Enclosure No 1
to
Bulletin No BO-25/2018 MDM-1 FOX

INSTRUCTION

Modification of Bowden cable of C.G. release

glider: MDM-1 Fox

Fig. 1 Scheme of Bowden cable's on PVC foam (side elevation)

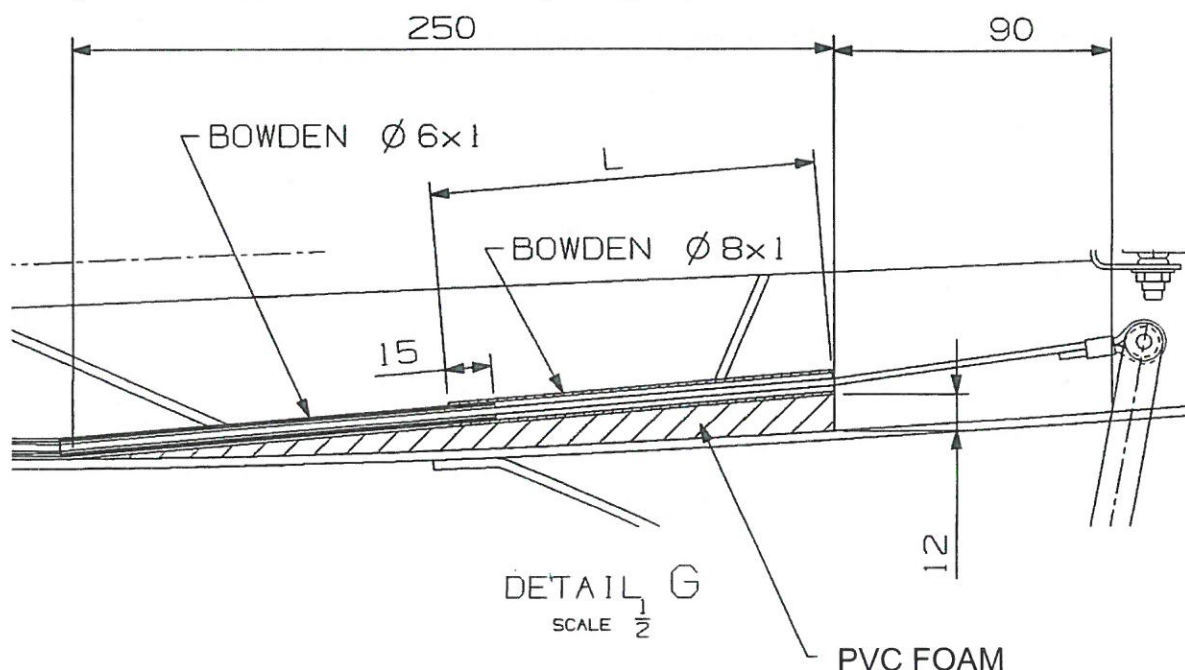
- c) Prepare tools and materials needed for modification, following the general guidelines for the manufacture of aircraft composite structures.
- d) Prepare PVC foam (acc to Fig. 1 and Fig. 2), fitting its shape to the fuselage.

- e) Remove a top layer of paint and filler inside the fuselage in the area of modification, by grinding it down to bare composite.
- f) Free the part of the Bowden cable $\text{Ø}6 \times 1$, adjust prepared piece of PVC foam, and ensure a smooth transition of cable to new position. Determine the length of the new $\text{Ø}8 \times 1$ Bowden outer sheath and trim it to the right dimension (according to the picture below). If needed, cut the outer housing along to put on a steel cord.

Fig. 2 Scheme of Bowden housing lamination (front view)

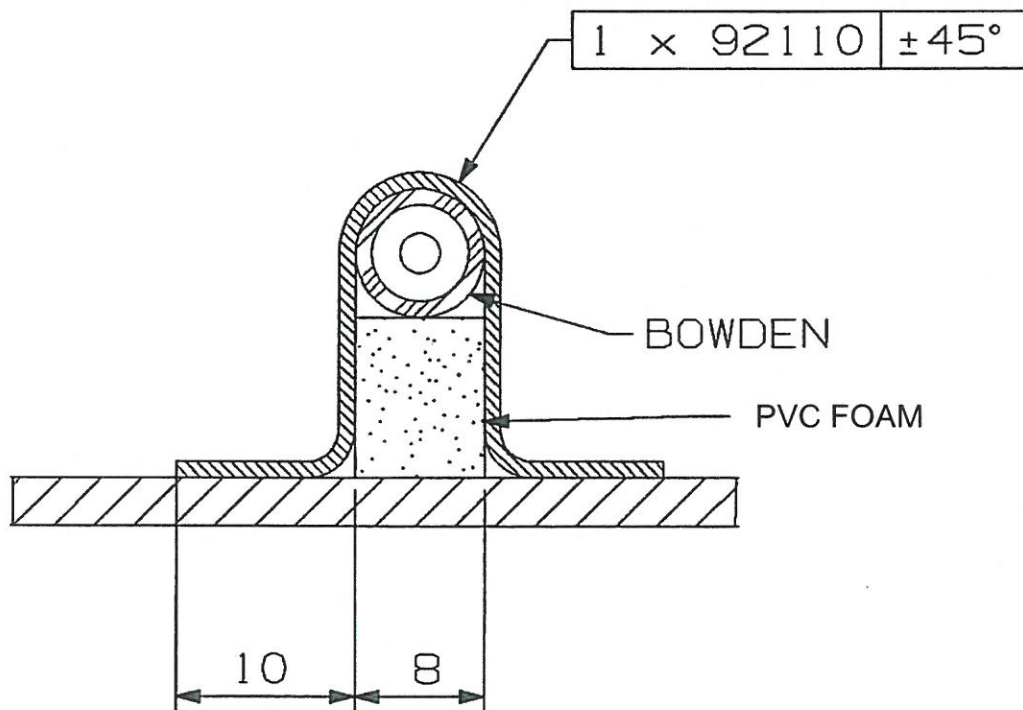
- h) Bond in the PVC foam (prepared earlier). Connect Bowden outer housing $\text{Ø}8 \times 1$ and $\text{Ø}6 \times 1$, through pulling $\text{Ø}8 \times 1$ over $\text{Ø}6 \times 1$, over a length of 15mm. Provide the smooth transition between both Bowden cables – composition for lamination: EP53/Z1+Aerosil. Carry out following general guidelines for the manufacture of aircraft composite structures.
- i) Laminate with glass fabric $1 \times 92110 / \pm 45^\circ$ using EP-53/Z1 composition (acc to Fig. 2 and Rys. 3), secure the laminated surfaces with the peel-ply.

Fig. 4 Preparation of the new cord

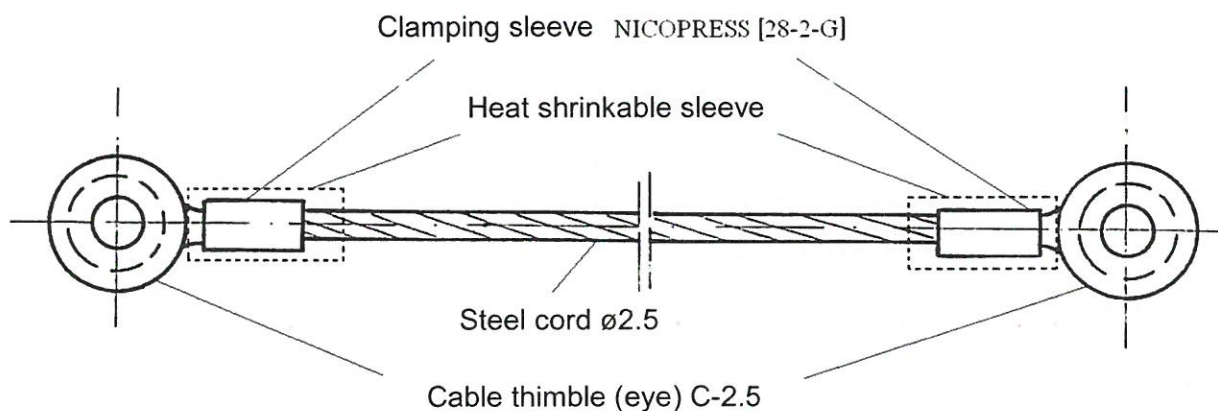
n) Mount the C.G. release cord and all other mechanism components removed for the repair. In case of replacing the steel cord, the following steps should be done:

- Crimp the clamping sleeve on one end of the steel cord.
- Determine a total length of the cord
- crimp the second clamping sleeve on the other end of the steel cord

Check accuracy of preparing the new linkage according to general guidelines for the manufacture of aircraft linkage components by sleeve crimping, and to the following sketch (Fig. 4).
